CITY PLAN COMMISSION REPORT

Barry Road Townhomes

16 CD-CPC-2022-00075
Development Plan
(w/ preliminary plat)

CD-CPC-2022-00075 - A request to approve a development plan and a preliminary plat for the construction of 86 townhomes in District R-1.5 (Residential 1.5)

PRELIMINARY TREE PLAN
1" = 60'-0"

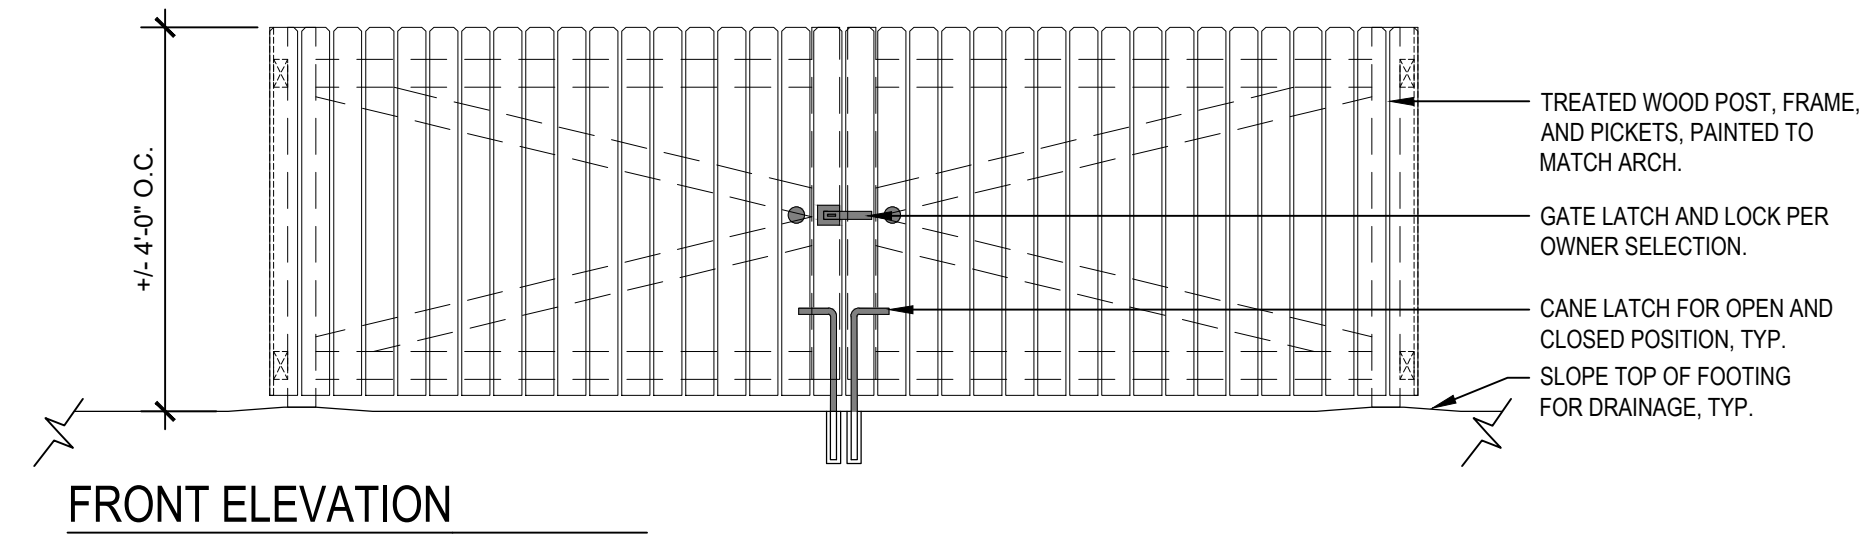
A landscape plan has been submitted by the applicant. The plan is not compliant with Code and will require a deviation to the required amount of street trees (88-425-03). The Code requires a total of 164 trees and the applicant is only proposing 132 trees due to existing easements and intervening roadways; staff does support the administrative adjustment in the reduction of the proposed street trees. The applicant also did not provide staff with the total amount of trees that will be removed due to construction. Staff has conditioned that the applicant provide the total amount of trees that will be removed prior to ordinance request pursuant to (88-516-05-1).

The applicant did not provide staff with the exact number of trees that will be removed which is required by Code.

7. Provide a higher quality lap siding (not vinyl) for any structures visible from Barry Road.
8. Provide number of trees that will be removed for construction pursuant to 88-516 prior to ordinance request.

CLUB FRONT ELEVATION

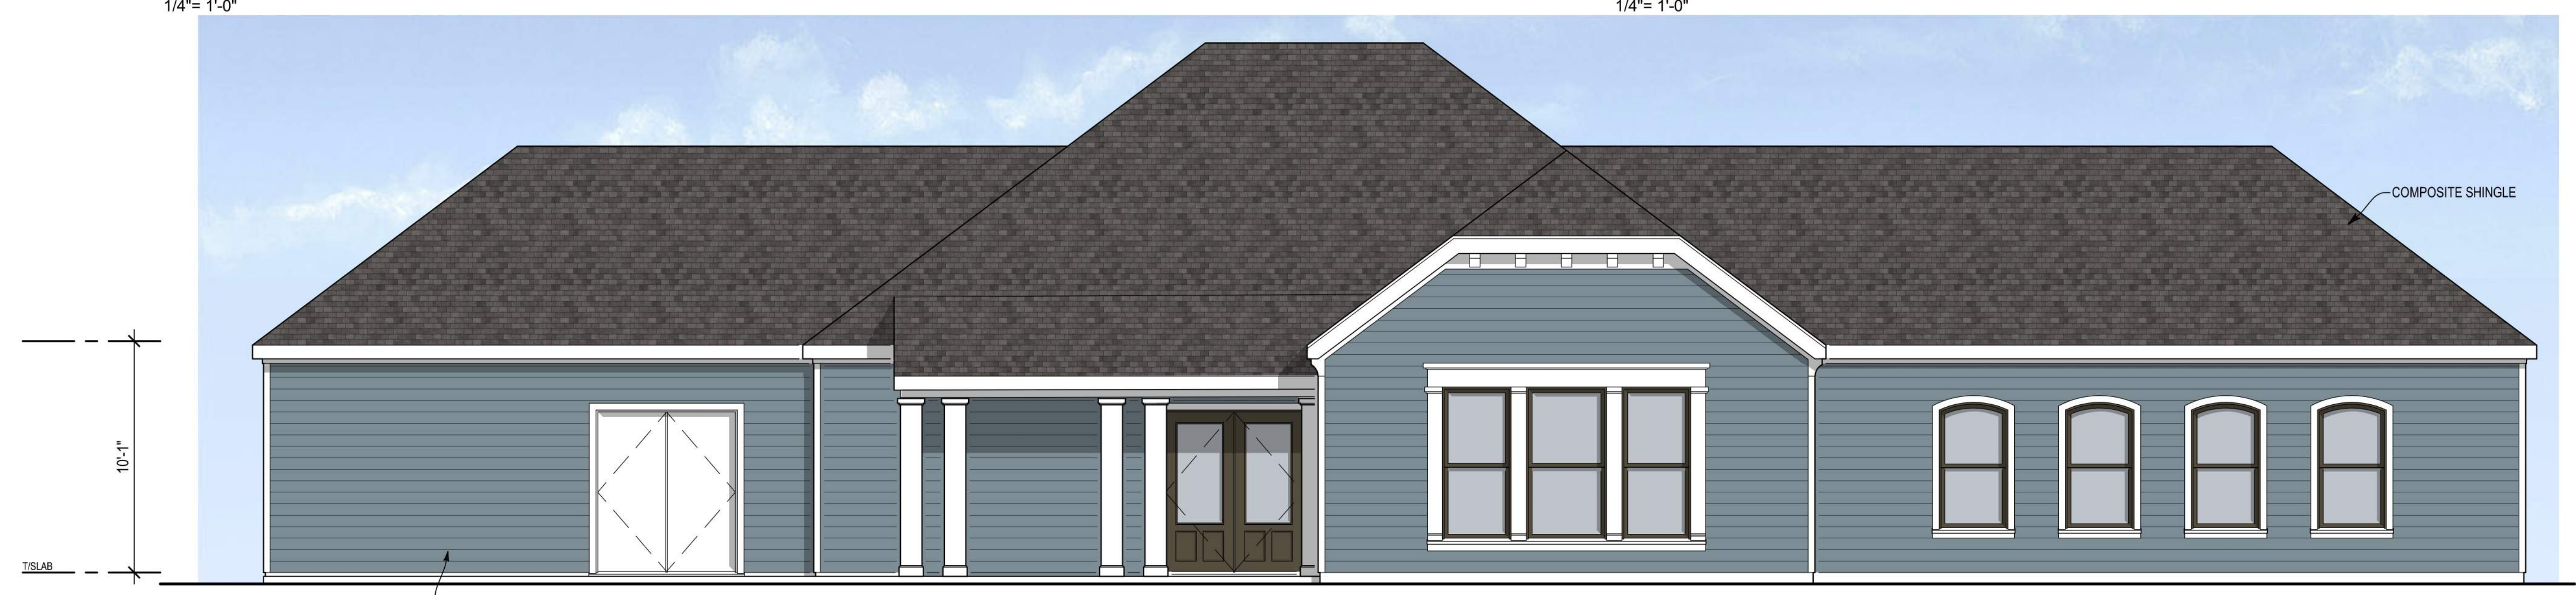
Staff supports the overall design concept and density that the applicant has proposed. The architectural scale and character fits the surrounding area. The primary building materials proposed are white vinyl siding, adhered simulated stone (grey in color), black composite shingles and a dark bronze color for the window frames. Staff does appreciate the number of windows that are being proposed. Staff has requested that the applicant provide a higher quality material such as fiber cement lap siding instead of vinyl. If the applicant cannot provide a higher quality material staff does recommend that the vinyl siding is not visible from Barry Road.

The primary building materials proposed are white vinyl siding, adhered simulated stone (grey in color), black composite shingles and a dark bronze color for the window frames. The proposed architectural styles compliment the surrounding area.
